## Montgomery County Complete Streets Design Guidelines Work Session #3

**Completed: 10/01/2020**

**Attachment A**  
Summary of Comments Received and Proposed Responses  
**Work Session #3**

**Comments from MDOT SHA**

**Figure 1: Revised Graphic for Figure 1-3 in Guidelines**

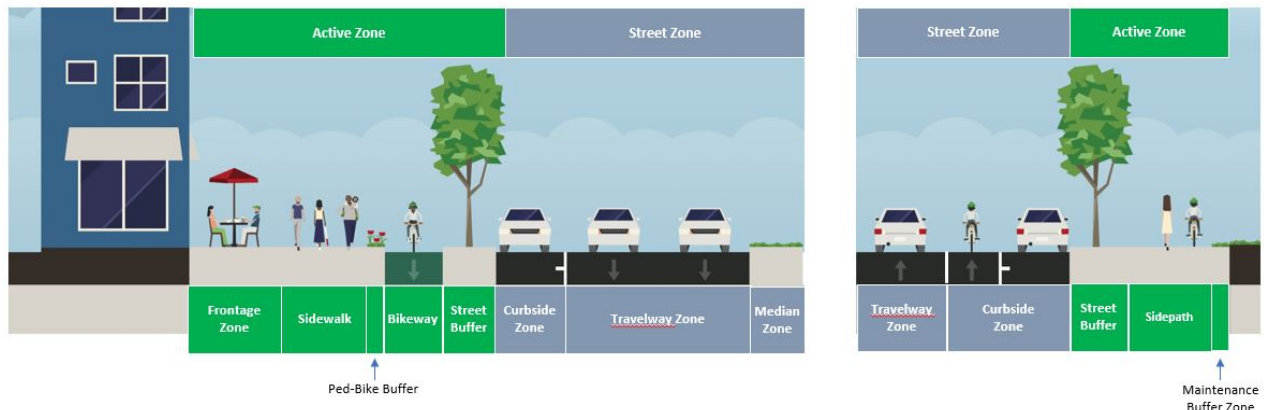
1. Relocation of a revised version of Figure 1-3 with more explanations on the basic zone structure to be placed at the beginning of Chapter 2 before the introduction of the 12 street types. Two different cross sections would be shown in this revised graphic to identify where bike facilities can occur, as they are not located in the same place for every street type. One example would show a separated bike lane and the second example would show an on-road bike lane and a sidepath. A sketch developed using the Streetmix software (see Figure 1 on the following page) shows how this graphic would be modified. The version to be used in the revised document would be consistent in format to graphics in the current CSDG document. A paragraph would also be added to clearly describe this graphic and the general zones, as well as the fact that bicycles accommodations can occur in three different places, a bikeway or sidepath in the Active Zone and a bikeway in the Street Zone.

191	Jack Cochrane, Montgomery Bicycle Advocates	55	Figure 3-2	Bikeways	If the bikeway is a conventional bike lane (or buffered bike lane), this statement is not true: "The street buffer is the space between the travel or parking lanes and the bikeway or sidewalk." The line needs to indicate which bikeway type(s) it's referring to, and do it correctly.	To address this comment, staff proposes combining Chapters 2 and 3 so that all information is organized by street type. An example of this is provided in Figure 1 in the staff report.
192	Jack Cochrane, Montgomery Bicycle Advocates	55	Figure 3-2	Table	Generally sentences of that form are difficult to parse. Instead of saying "between A or B and X or Y", say "between A or B on one side, and X or Y on the other".	Thank you for your comment. Reader clarity is important. We will review the CSDG to address issues similar to the example provided.
193	Jack Cochrane, Montgomery Bicycle Advocates	55	Figure 3-2	Bikeways	If on-street parking is part of the buffer zone and abuts the Pedestrian Clear Zone... How can parking be part of the buffer zone? This contradicts the statement "The street buffer is the space between the travel or parking lanes and the bikeway or sidewalk."	To address this comment, staff proposes combining Chapters 2 and 3 so that all information is organized by street type. An example of this is provided in Figure 1 in the staff report.
